TRANS/WP.29/GRPE/2003/14/Add.1
29 October 2003

PROPOSAL FOR DRAFT AMENDMENTS TO THE NEW DRAFT REGULATION ON

- I. SPECIFIC COMPONENTS OF MOTOR VEHICLES USING LIQUID HYDROGEN
- II. VEHICLE WITH REGARD TO THE INSTALLATION OF SPECIFIC COMPONENTS FOR THE USE OF LIQUID HYDROGEN

Transmitted by the members of the informal group "hydrogen / fuel cell – vehicles"

Figure 1 – Ranges of a steel inner tank

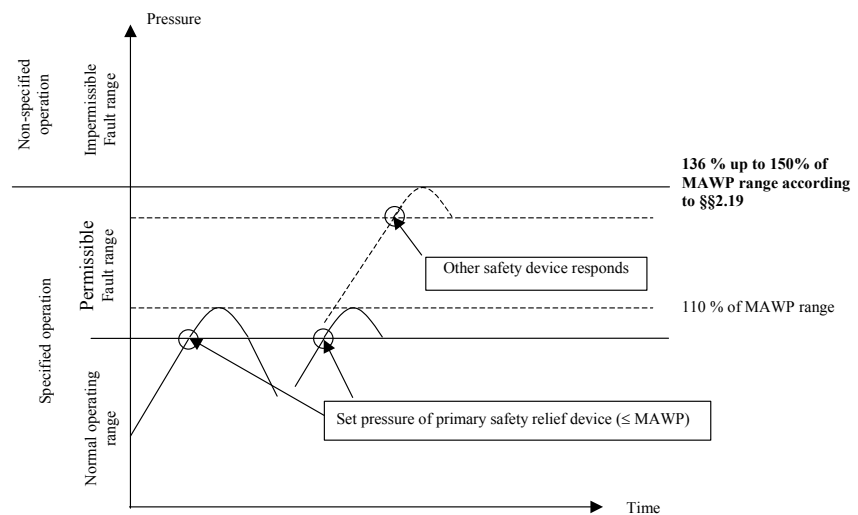
Paragraph 2.19., amend to read:

"2.19. "Impermissible fault range" of a process variable means the range within which an unwanted event is to be expected, e.g. the corresponding pressure where from plastic deformation or bursting of the inner tank occurs as shown in Figure 1. In the case of steel inner tanks, the lower limit of the impermissible fault range corresponds to a pressure higher than 136 per cent of the Maximum Allowable Working Pressure (MAWP) of the inner tank **if a safety valve is used as second pressure relief device. In case of steel inner tanks, the lower limit of the impermissible fault range corresponds to a pressure higher than 150 per cent of the Maximum Allowable Working Pressure (MAWP) of the inner tank if a burst disk is used as second pressure relief device.** For other materials an equivalent level of safety is to be applied.

1. Ad paragraph 2.19.:

General requirement:

Safety requires that no plastic deformation of the inner tank occurs.

Current Problem:

The tolerance fields of first PRD (safety valve) and second PRD (burst disc) do partly cover. As a result, in some cases the second PRD came into operation before the first and therefore the first PRD did not come into operation at all.

Solution:

Moving the set pressure of first and second PRD away from each other would improve the situation. Since ISO 13985-1 requests an operating pressure for burst discs between 120 per cent and 150 per cent of MAWP, a set pressure of 150 per cent would still be suitable.

Furthermore, in case the burst disc is located inside the vacuum, the set pressure of the burst disc can be set to MAWP+0.1MPa, since the calculation is based on overpressure.
